FORM APPROVED
OMB No. 1004-0137
Expires: October 31, 2014**SUNDRY NOTICES AND REPORTS ON WELLS**
Do not use this form for proposals to drill or to re-enter and man
abandoned well. Use Form 3160-3 (APD) for such proposals.5. Lease Serial No.
V07843 & NM 295606. Indian, Allottee or Tribe Name
Name

Encana Oil & Gas (USA) Inc. is requesting authorization to install gas lift at the Lybrook I02-2308 01H well pad. Attached is a schematic of the pad with gas lift and the gas allocation procedure.

Lybrook I02-2308 01H & 02H

CONDITIONS OF APPROVAL FOR GAS LIFT, BUY BACK METER AND CDP INSTALLATION:

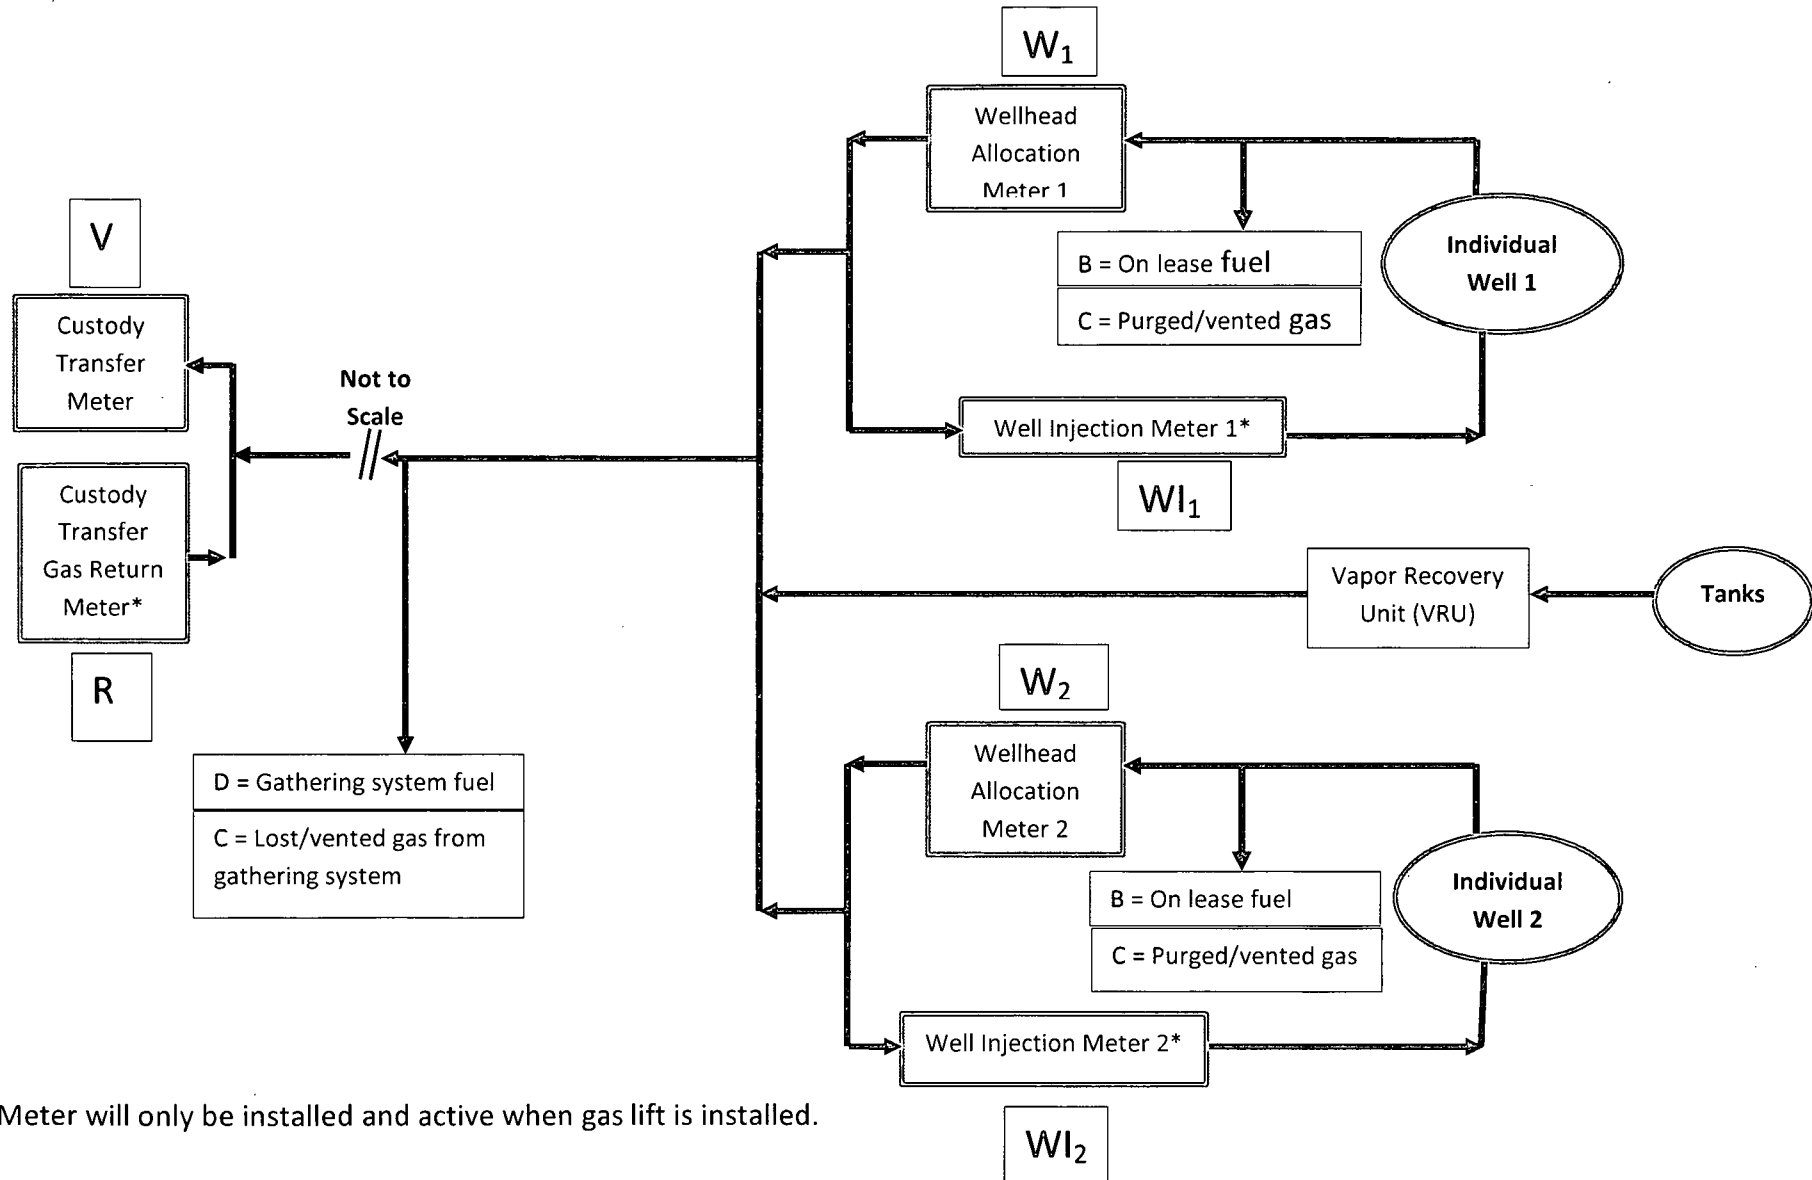
- The buy-back meter isolation valve, either up or down stream of the buy-back meter must be effectively sealed in the closed position to prevent produced gas from potentially by-passing the measurement and sales meter. In lieu of the seal requirement at least two check valves can be installed immediately upstream and downstream of the buy-back meter to prevent produced gas from potentially by-passing the measurement and sales meter.

Contact this office so a BLM witness may verify installation of either the seal or check valves.

- If seals are installed, seal records must be maintained and made available upon request.
- Post a Facility sign at the CDP listing the following information:
 - Operator Name
 - Facility Name (i.e. Lybrook I02-2308 01H CDP)
 - UL, S-T-R, County and State

Clearly identify both the sales and by-back meters.
